**INVITATION FOR BIDS (IFB) #26-002
HVAC EQUIPMENT & SERVICES AT THE
PINELLAS HEIGHTS SENIOR APARTMENTS**

ADDENDUM NUMBER ONE (1)

PCHA: Phase 1 Revision 1 Narrative for City of Largo

The need for submission of this revision is due to a discrepancy between the latest version of stamped mechanical plans and the version that was submitted for permitting. There are two changed items in this plan set compared with that approved by City of Largo: 1. Additional work scope to move CU-A-2-1 and 2. Change of OU-A-3 model. The details of the specific changes throughout the plan set are below.

M004
Piping Diagram &
Materials Tables

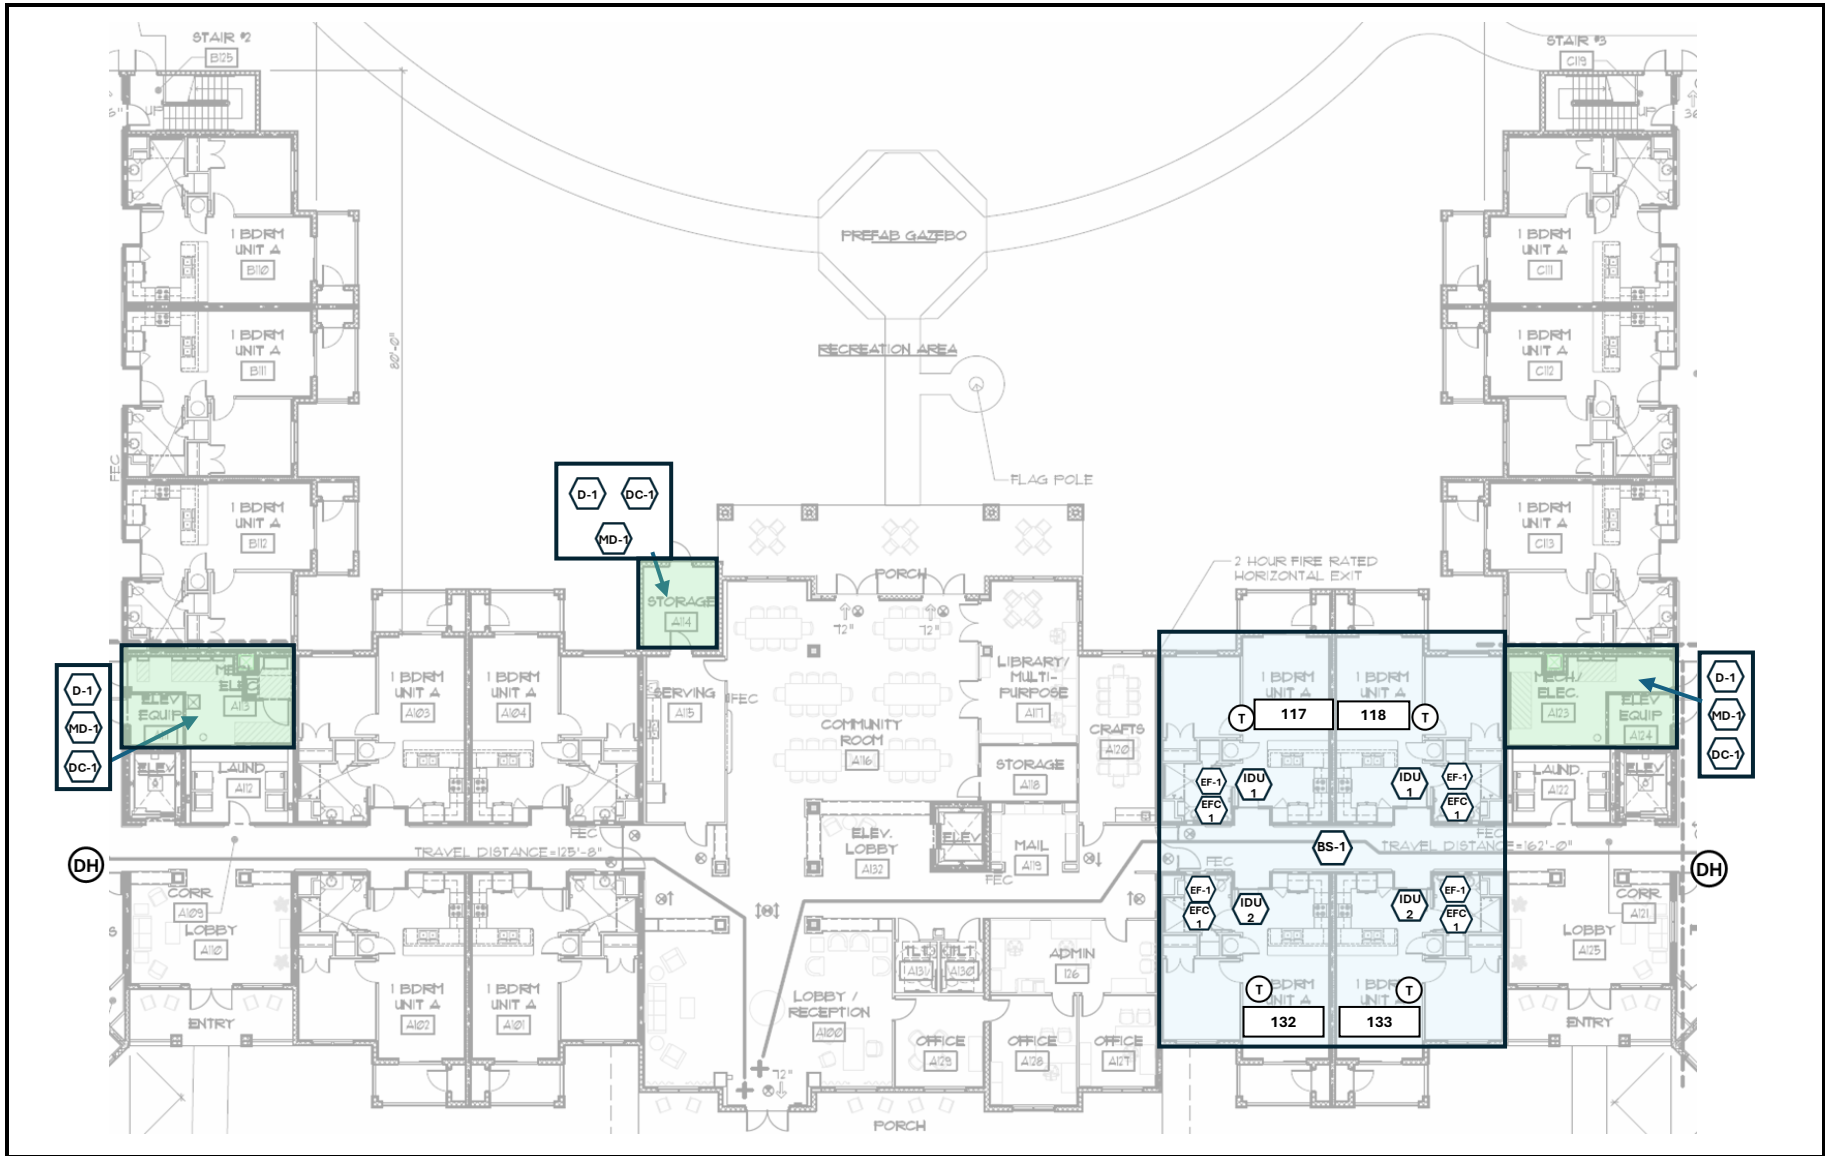
2. Outdoor Unit [OU-A-3] Equipment Change from 408 V to 208/230V

Change of OU-1 model:

Was Model #	Latest Model #	Plan Change Log Page
REYA168AAYDB 406V/60Hz/3φ	REYA168AATJA 208/230V/60Hz/3φ	M000 Sheet Key, Schedule [M000A&B], Schedule [M003A], Piping Diagram M004, Schedule [M004A]

Model	Qty	Description
REYA168AATJA	1	VRV EMERION (208/230V 3ph)
BSF4A54AAVJ	4	Branch selector unit
FXSA09AAVJU	8	FXSA_AA - Concealed Ducted (Medium Static)
FXSA12AAVJU	8	FXSA_AA - Concealed Ducted (Medium Static)
KHRP25A33TA	1	Refnet branch piping kit
KHRP25M72TUA	2	Refnet branch piping kit
BRC1NRV71	16	Navigation Remote Controller
R32	28.24	Extra refrigerant charge (lbs)

M105
Roof Mechanical Plan

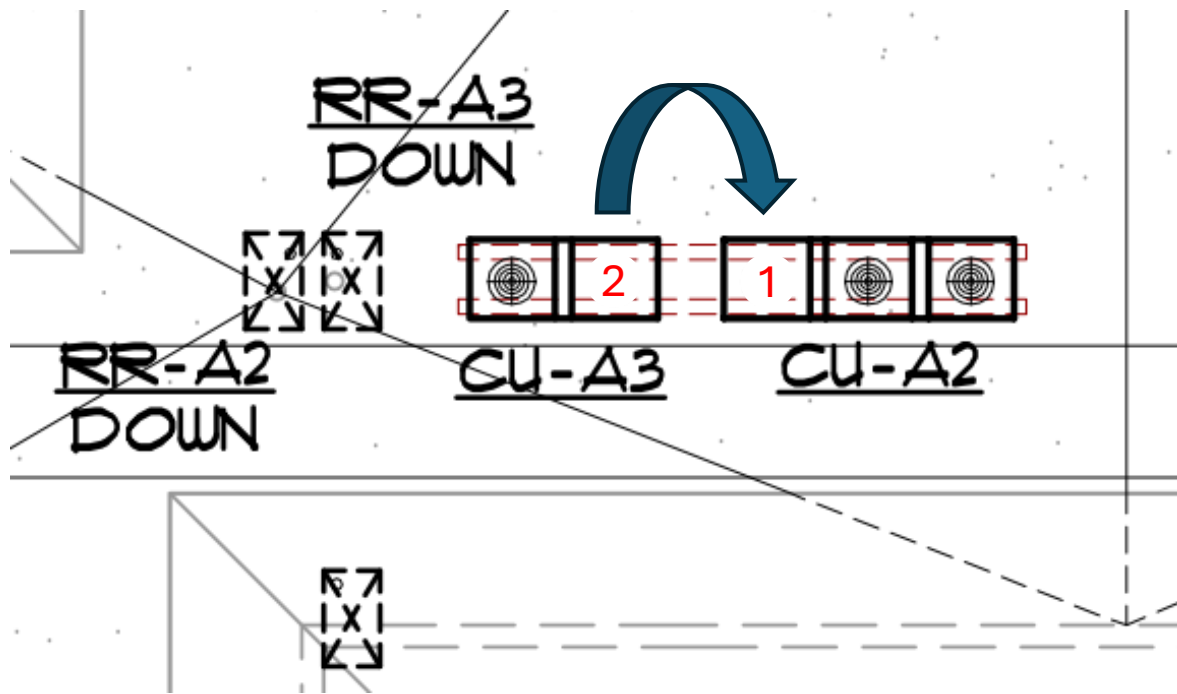
1. Additional Work Scope- CU-A-2-1 Move

The outdoor units CU-A-3-2 and CU-A-2-1 were originally mis-installed. Due to resizing, CU-A-3-2 is no longer needed but CU-A-2-1 will need to be pumped down, moved and recharged.

System CU-A3-2 and CU-A2-1 were installed backwards.

For this reason, the system marked 2 must be moved to the place where the system marked 1 is on the diagram on the left.

System CU-A2 must be pumped down, the system marked 2 moved, reconnected and recharged. Replacement system OU-A-3 only has a single unit so that the system marked 1 is to be removed.

*Installing contractor to verify in field.
